No. AS350-52.00.65

ALERT SERVICE BULLETIN

DOORS - Sliding doors

Double locking of the upper rail roller of the LH and/or RH sliding doors and locking markings

Figure 1

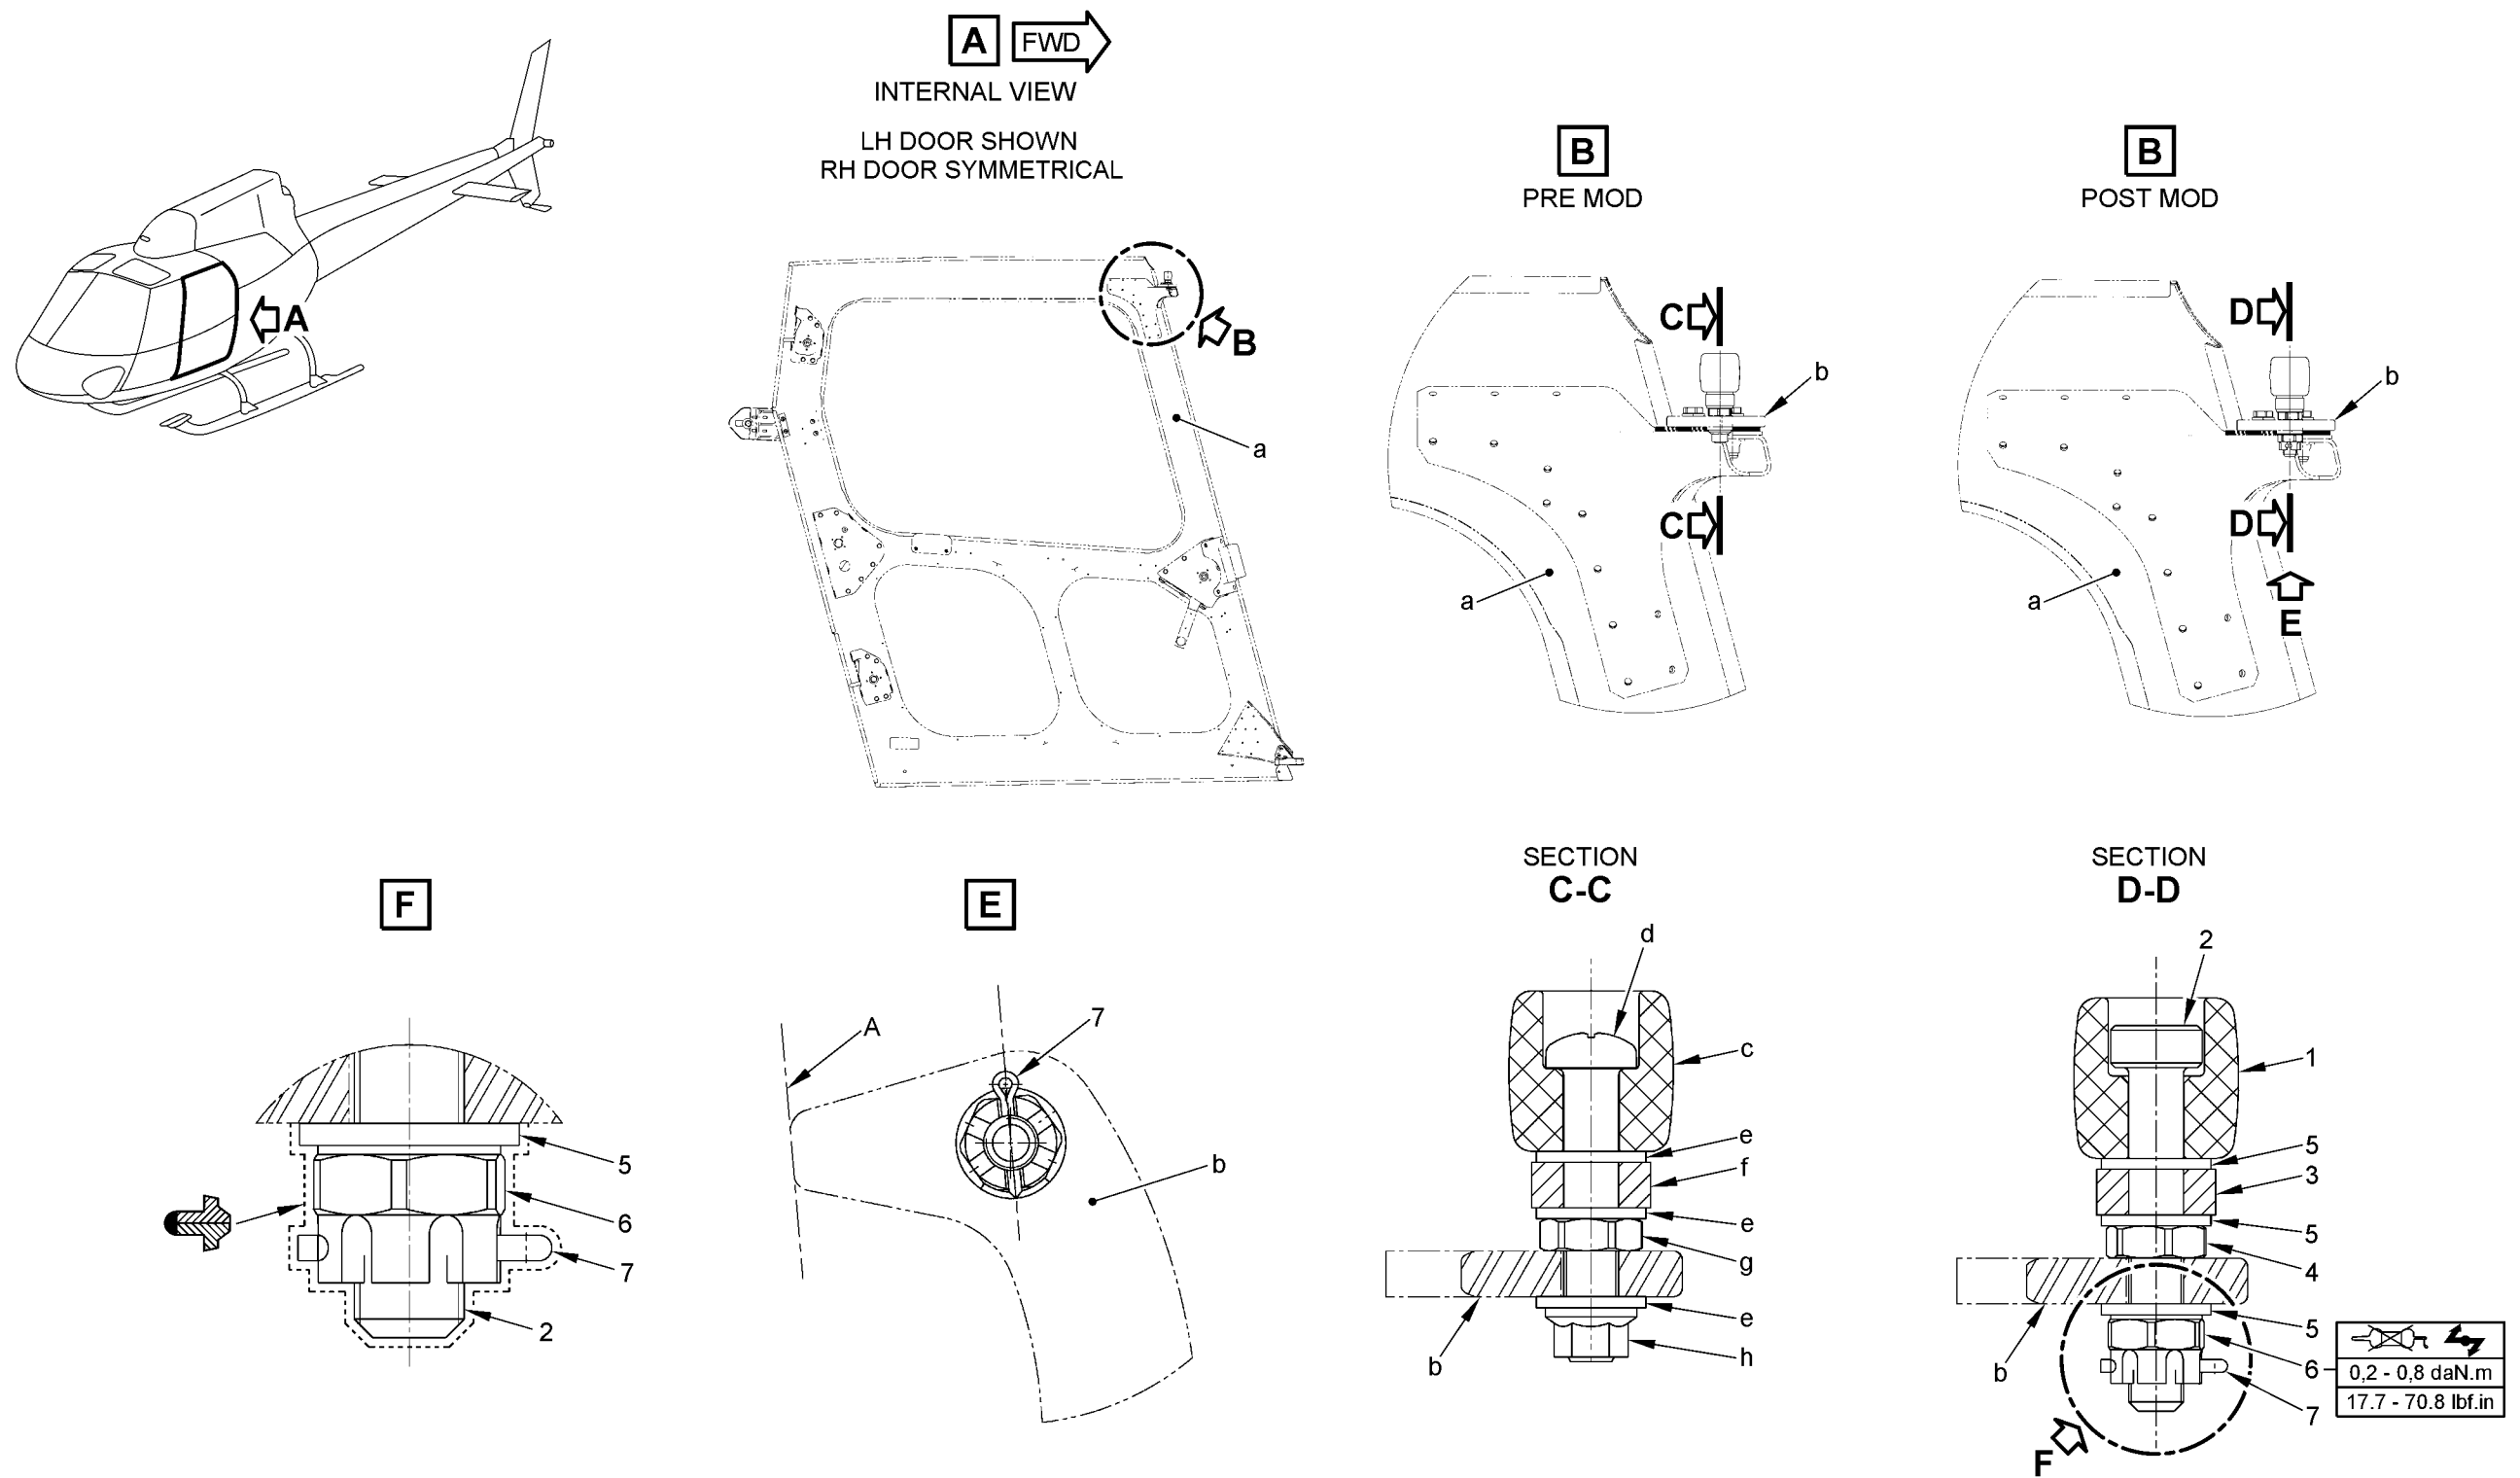
- Refer to the principle of:
 - . Task 52-12-00, 4-3 (AMM) (for B2 and B3 helicopter versions)
 - . Work Card 52-91-10-403 (MET) (for B, BA, BB, B1, D and L1 helicopter versions) to remove from the sliding door (a) (DETAIL B - PRE MOD and SECTION C-C):
 - . The hook (b)
 - . The hardware (not shown).
- Remove and discard from the hook (b) (DETAIL B - PRE MOD and SECTION C-C):
 - . The roller (c)
 - . The screw (d)
 - . The flat washers (e)
 - . The spring washer (f)
 - . The nuts (g) and (h).

- Install in the hook (b) (DETAIL B - POST MOD and SECTION D-D):
 - . The roller (1)
 - . The threaded pin (2)
 - . The spring washer (3)
 - . The nut (4)
 - . The flat washers (5)

- . The castellated hex. nut (6).
- Tighten the castellated hex. nut (6) to a minimum torque of 0.2 daN.m (17.7 lbf.in).
- After torque application, turn the castellated hex. nut (6) a maximum of 1/6 turn (without exceeding a maximum torque of 0.8 daN.m (70.8 lbf.in)) to align the hole of the threaded pin (2) with the following slot.

- Install the split pin (7) in the castellated hex. nut (6).
- Make sure that the split pin (7) is parallel to the axis (A) of the hook (b) end (DETAIL E).

- Clean the work area.
- Apply a layer of sealing compound (48) on (DETAIL F):
 - . The threaded pin (2)
 - . The washer (5)
 - . The castellated hex. nut (6)

Figure 2

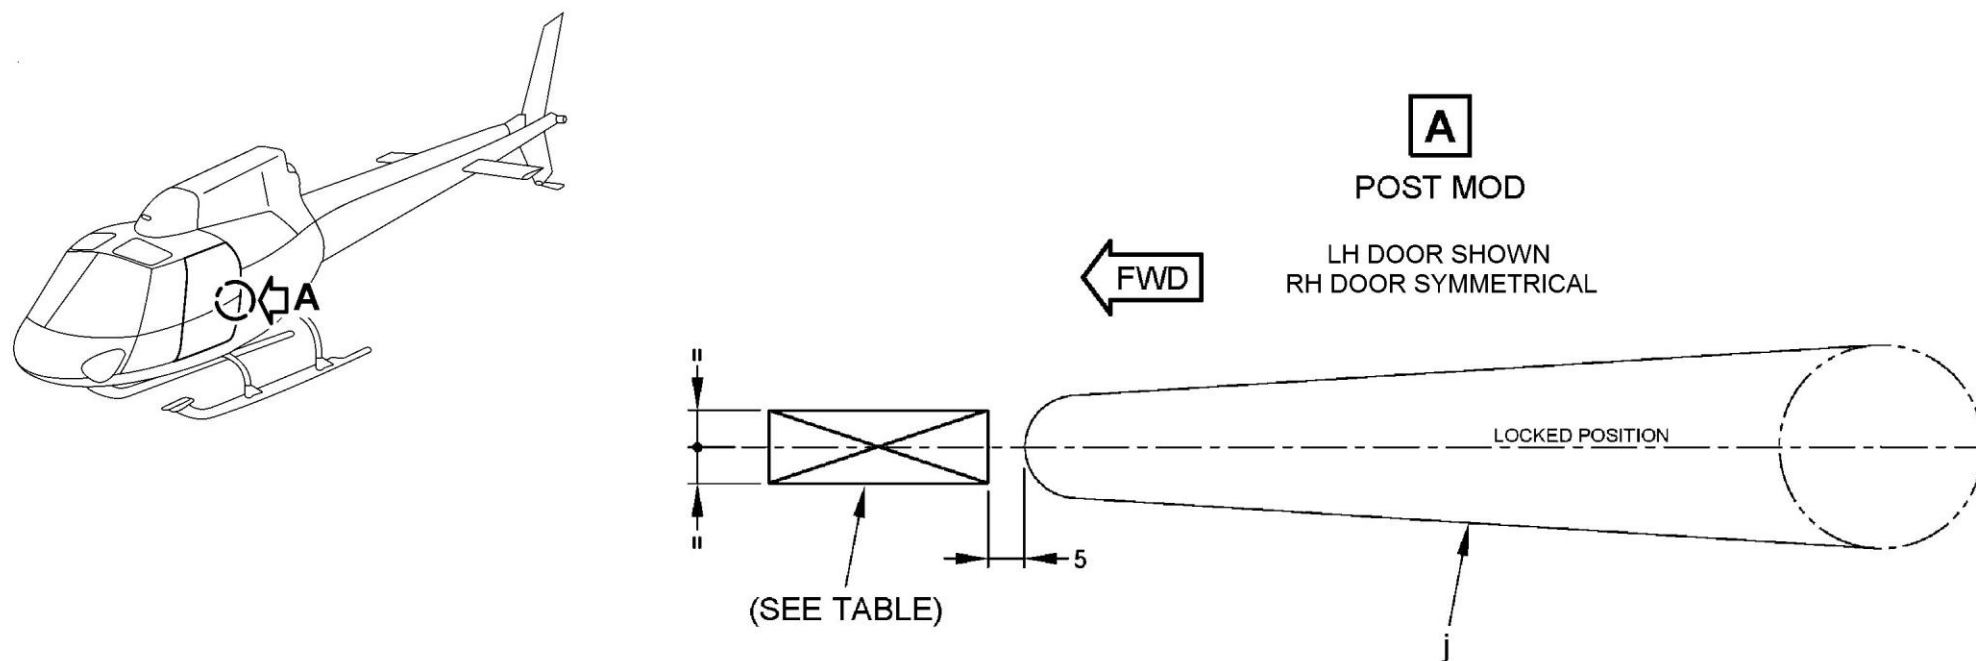
- Clean the work area.
- Bond the label on the external face of the sliding door (a) in line with the correct locking position of the handle (j) (DETAIL A - POST MOD).

Figure 3

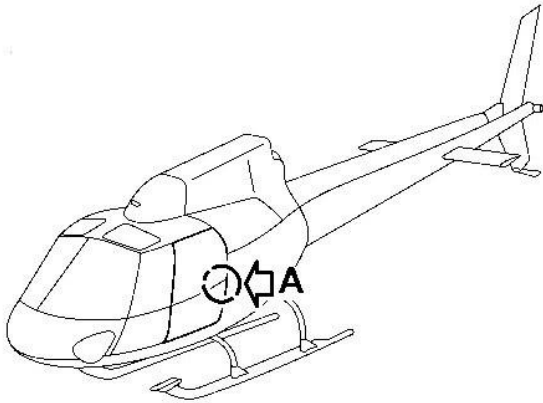
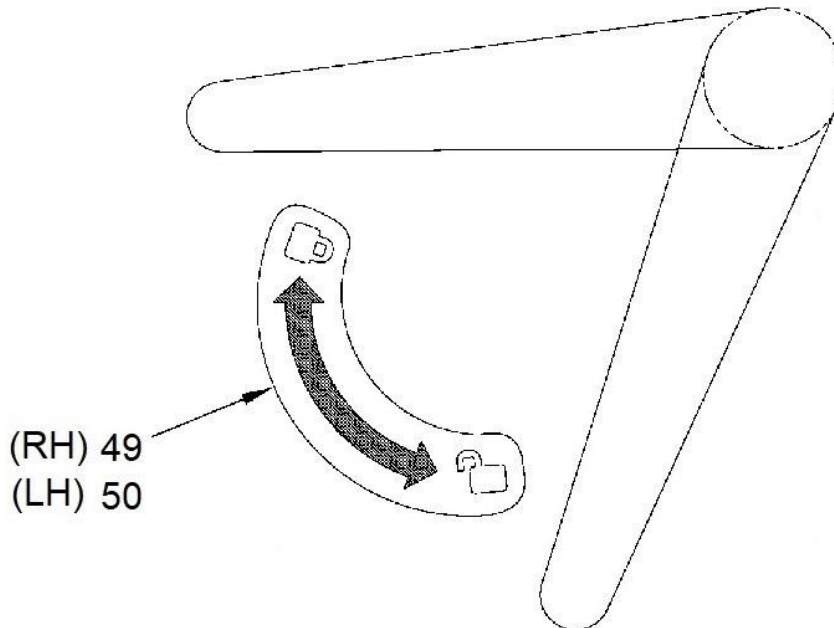
- Clean the work area.
- As applicable, bond the open door cabin LH label (50) and/or RH label (49) to the external face of the sliding door (a). Refer to the correct opening position and the correct closing position of the door handle (DETAIL A).
